**HISTORIC PRESERVATION COMMISSION
SEPTEMBER 26, 2019
ASSEMBLY HALL
395 MAGNOLIA RD.
PINEHURST, NORTH CAROLINA
4:00 PM**

**HISTORIC PRESERVATION COMMISSION
REGULAR MEETING
AUGUST 22, 2019
ASSEMBLY HALL
395 MAGNOLIA RD.
PINEHURST, NORTH CAROLINA
4:00 PM**

COA 19-057

MODIFIED FLOOR PLAN
MODIFIED ELEVATIONS

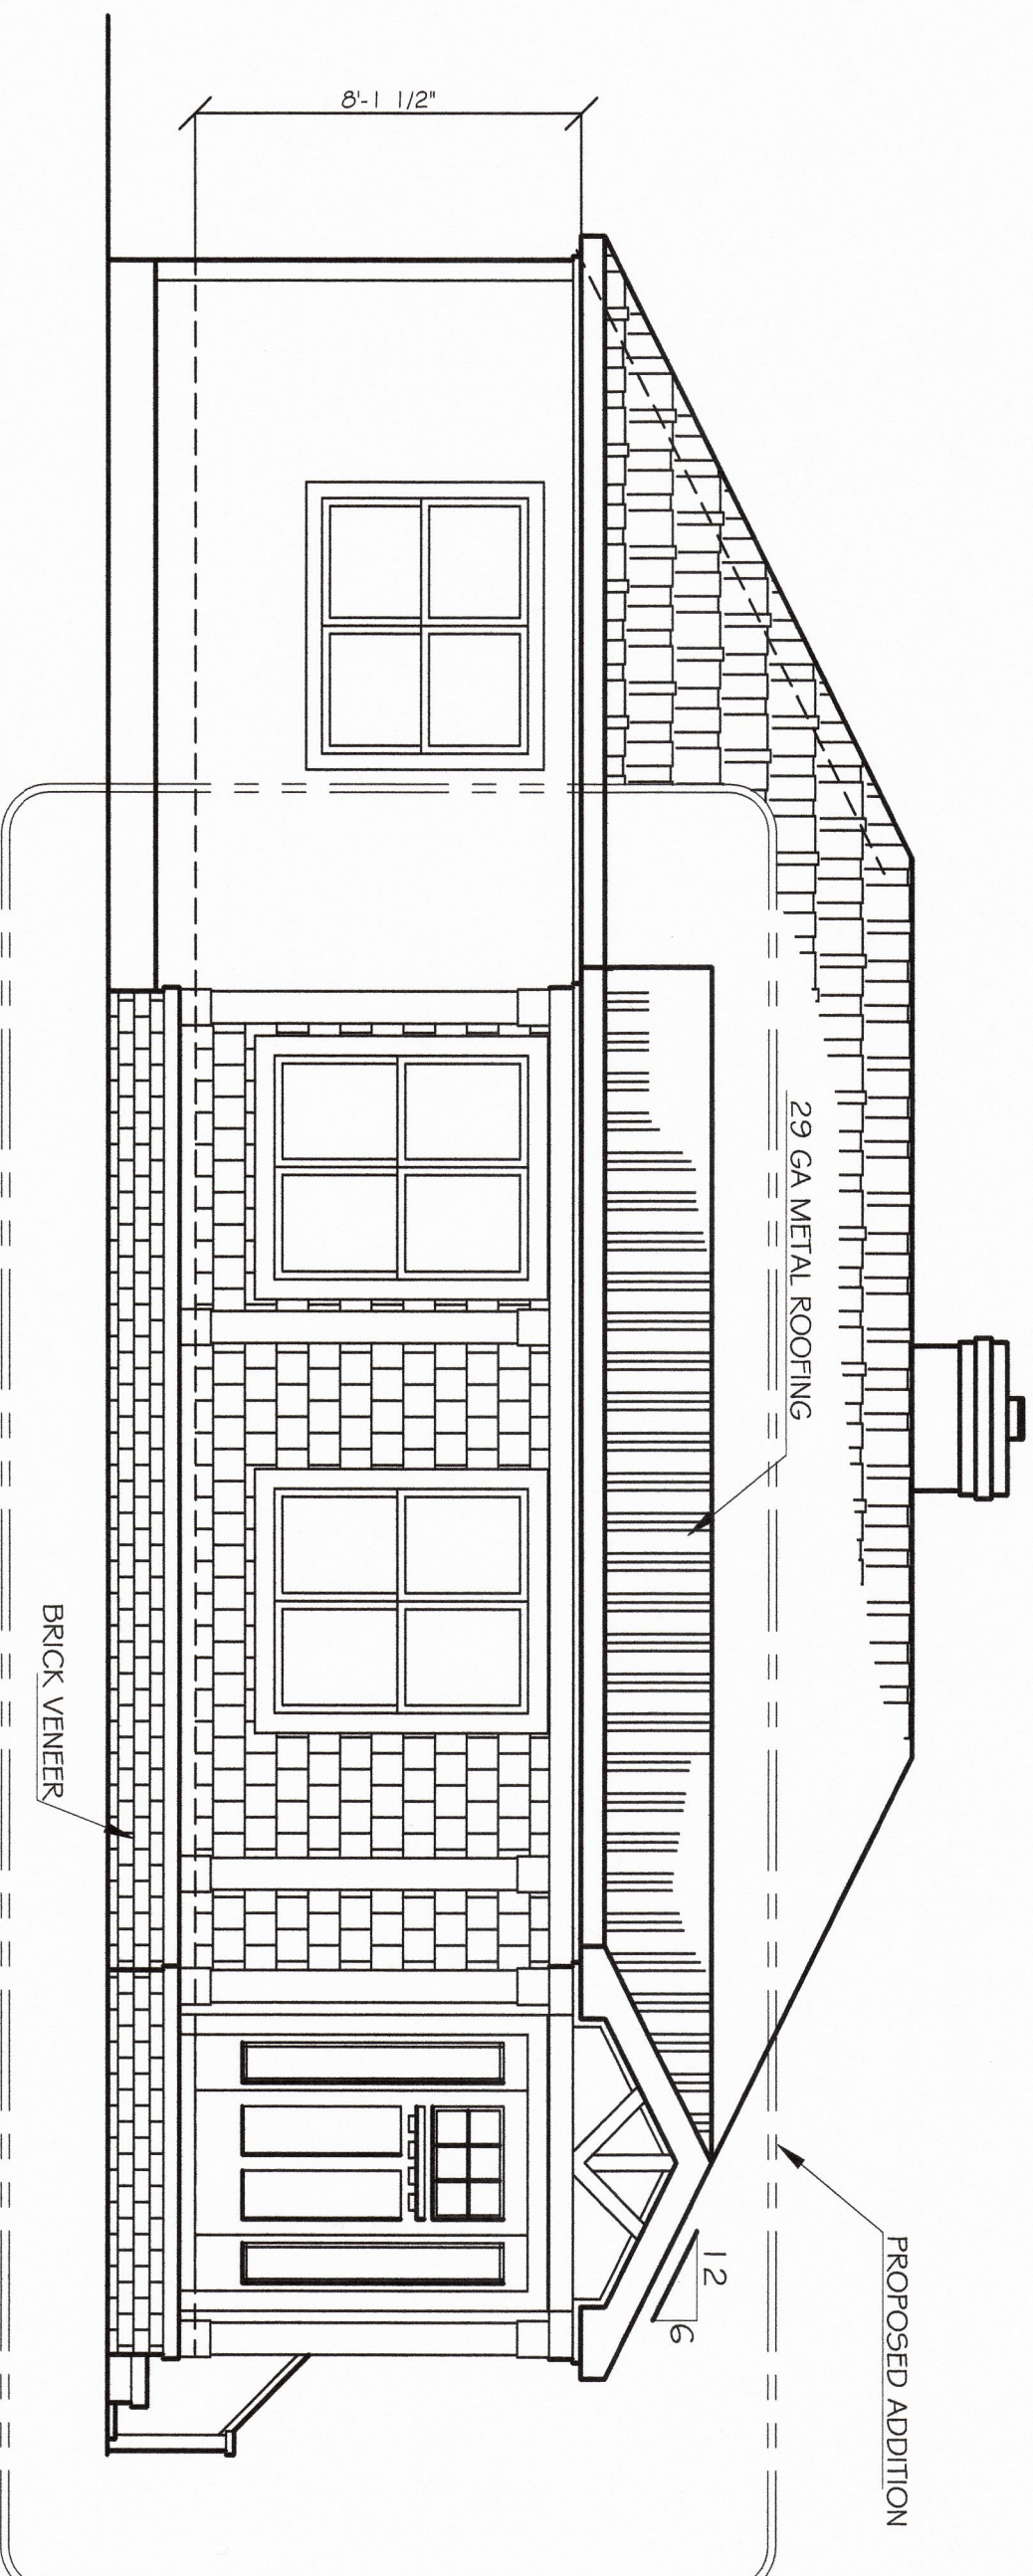
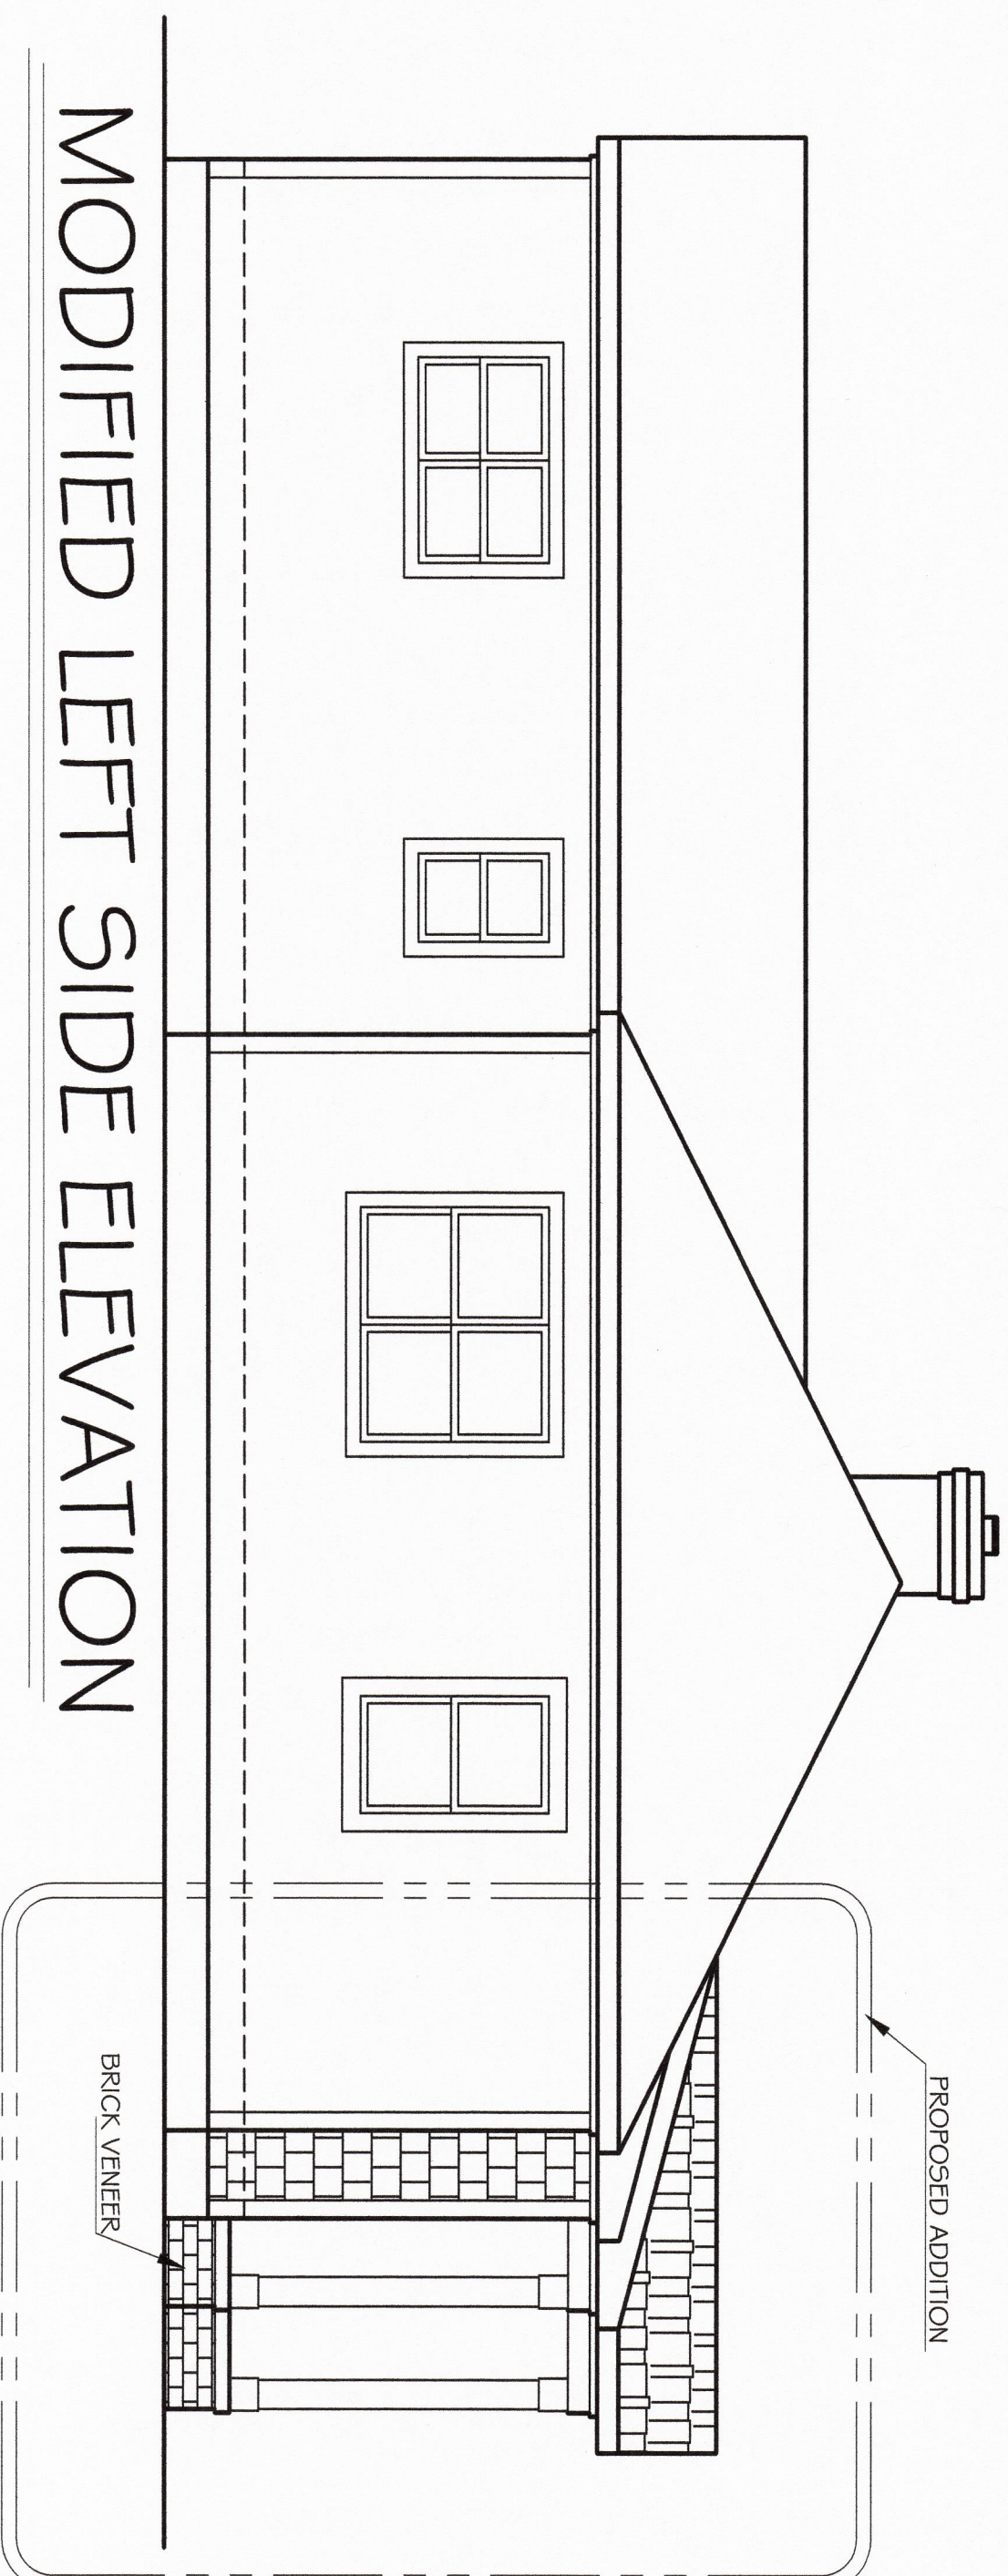
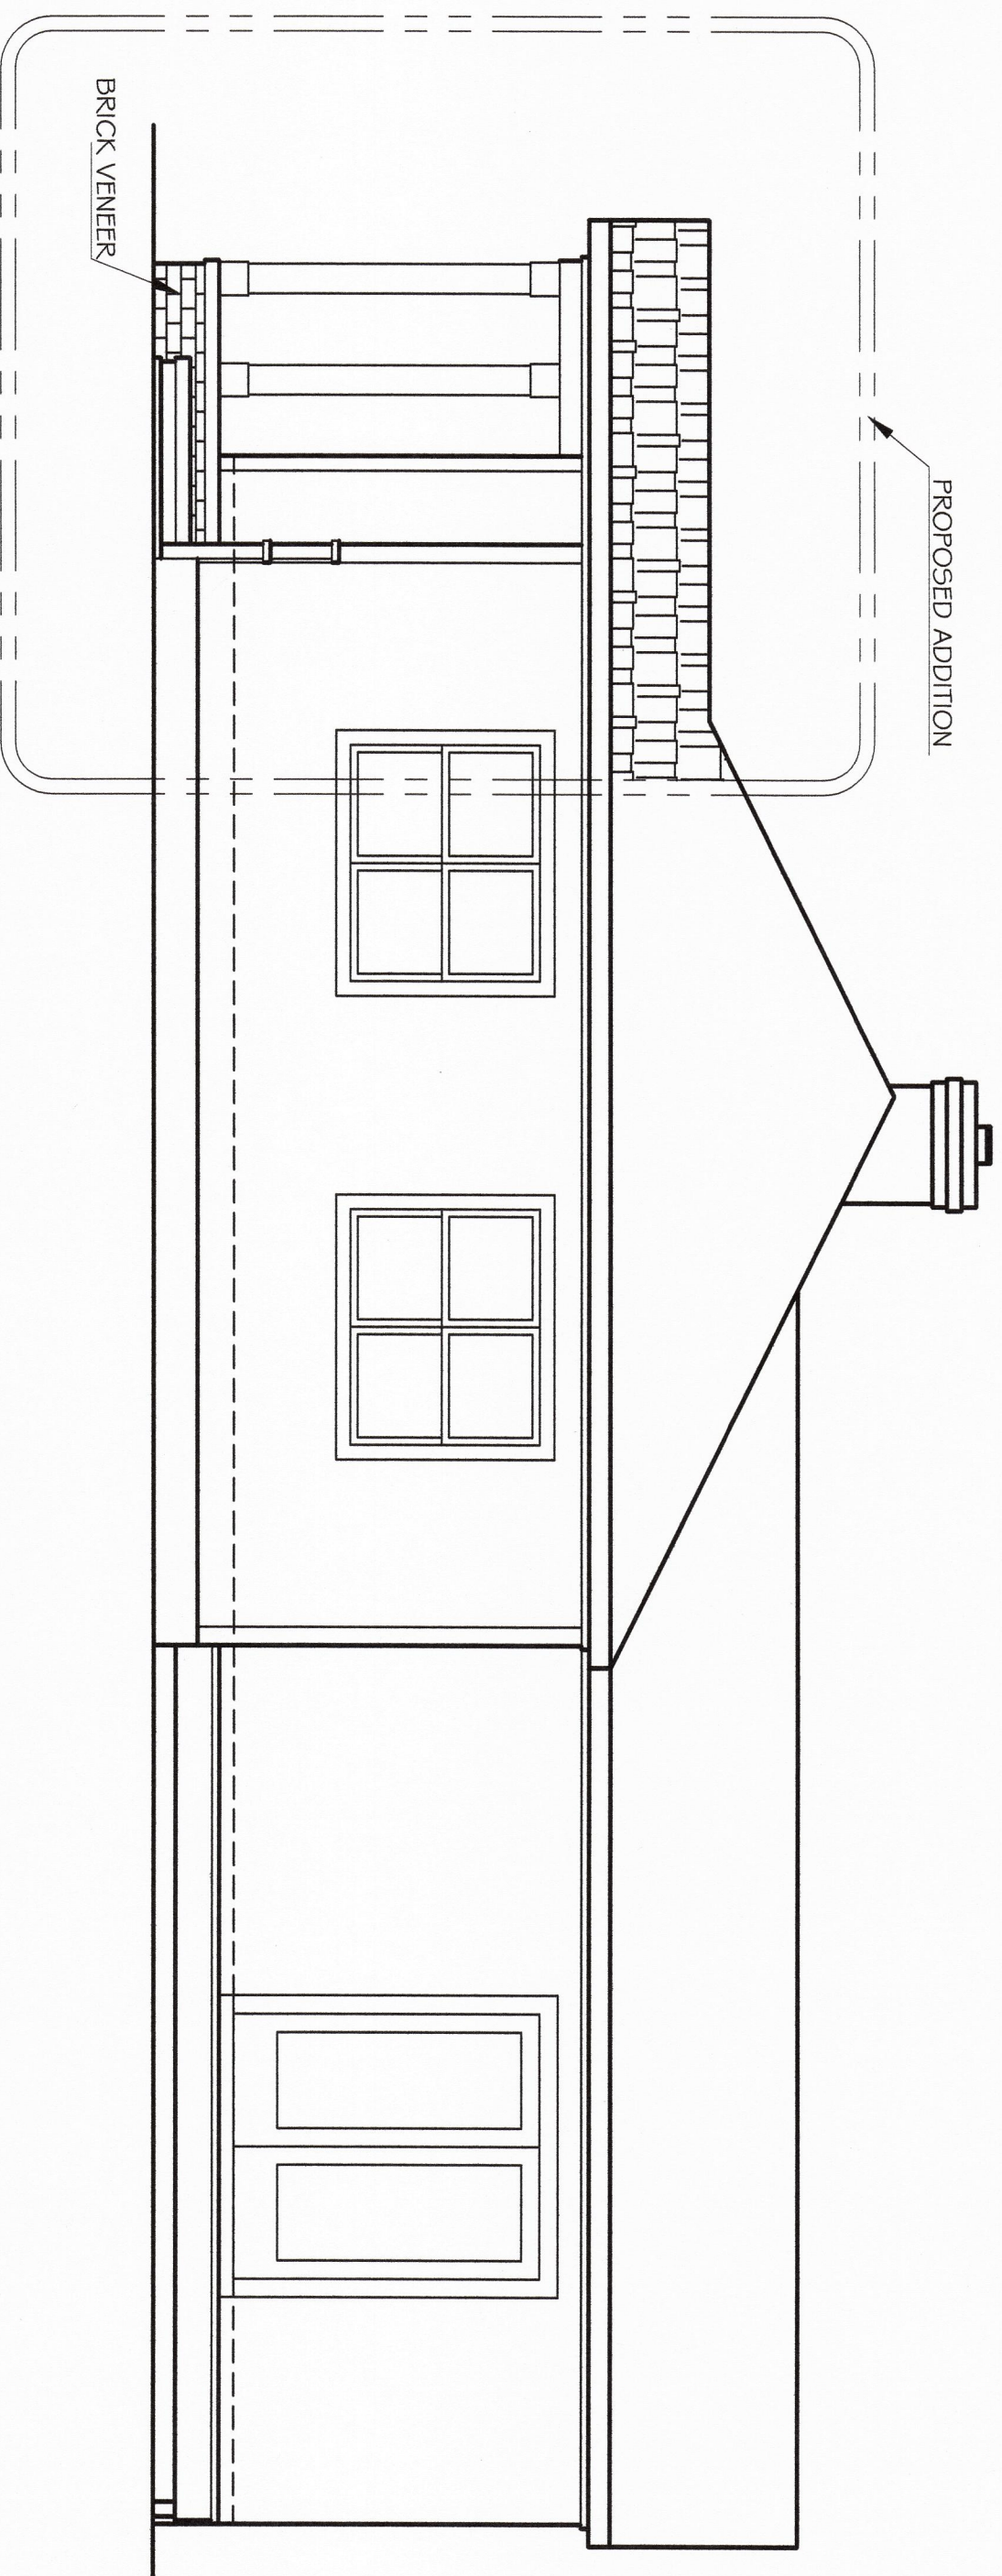
The Board commented that the elevation drawings were still incorrectly labeled as "existing: instead of "modified." The Board noted that the proposed elevation drawings depicted four-over-one windows, which were inconsistent with the proposed materials list.

Commissioner Richard Vincent asked that the applicant provide clarity on the color of the front squared columns, as they were depicted as cedar in the drawing and white on the materials list.

- 2) new windows – white vinyl to match existing
- New stain grade craftsman style front door
- Siding – vinyl shakes to match existing
- Brick – to match existing
- 4) white 6" squared columns
- 1x6 T&G ceiling
- Broom finish concrete on porch
- 5v interlocking 29ga screw down metal – color black

1. Front door - early American by minwax for the stain color
2. Vinyl shakes - "grey" to match home.

1 ELEVATION

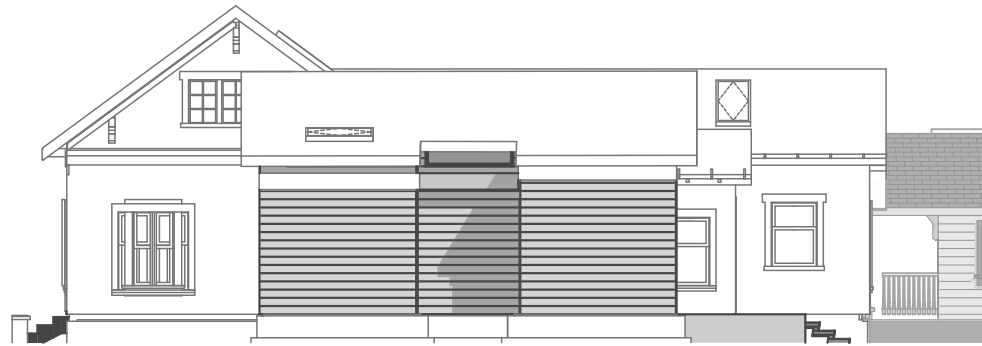
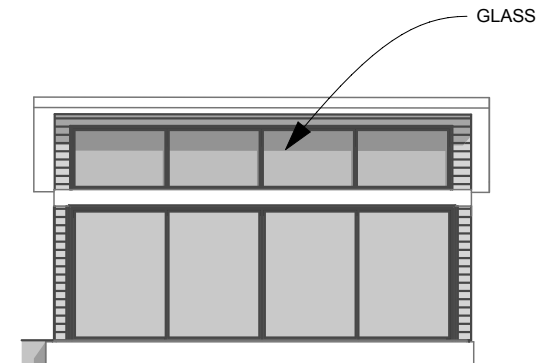
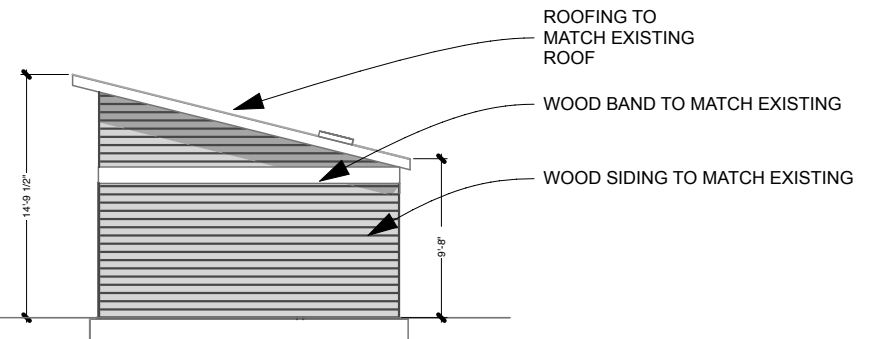
1. Article 4.E.1, *All proposed site features and accessory buildings, including garages, and other buildings, as well as other structures such as gazebos, patios, arbors, and pergolas, must be compatible with features of the principal structure and must be congruous with other accessory structures in the Pinehurst Historic District.* The applicant is proposing an accessory structure that will be compatible with the features of the existing principal structure and will be congruous with other accessory structures

2. Article 4.E.2, *Accessory buildings must be equal or lower in height than the primary structure and the roof should have an equal or lower slope than the primary structure.* The accessory building is proposed have a height of approximately 14.8', which is not taller than the primary structure, and the roof slope is proposed to be equal to the slope of the primary structure.

3. *A lower roof slope for an accessory building creates appropriate spatial definition of the two structures. The slanted verses a more common pitched roof meets this design goal.*

4. *New construction should not visually overpower nearby structures.* While the structure design to utilize natural light could be considered more modern, the location of the structure and exterior details do not visually overpower nearby structures and meet the intent of the design goal.
